Infonote

AO-IN-2026-002-I

Efficiency upgrade for OSOLON UV
3535 SU CULFP1.VC

01.06.2026

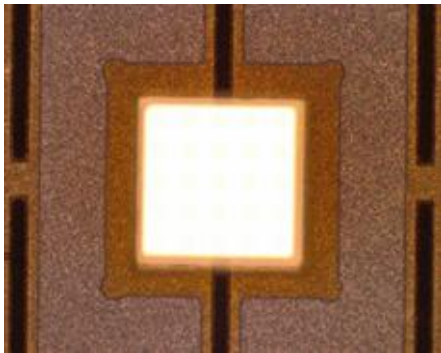
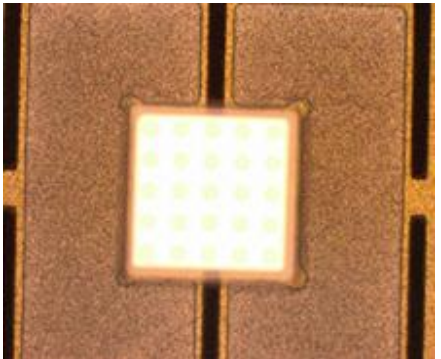
Objective:	Efficiency upgrade for OSOLON UV 3535 SU.CULFP1.VC and datasheet update	
Affected product:	SU.CULFP1.VC	
Reason for change:	Improve product performance by expanding substrate reflectivity area. Revised typical Vf based on verified production statistics.	
Description of change:	<u>Current status</u> Current substrate reflectivity area 	<u>New status</u> Expanded substrate reflectivity area 
	Datasheet version 1.8	Datasheet Version 1.9
Time schedule:	Starting from 01.06.2026	
Assessment:	No Change in fit, function and reliability.
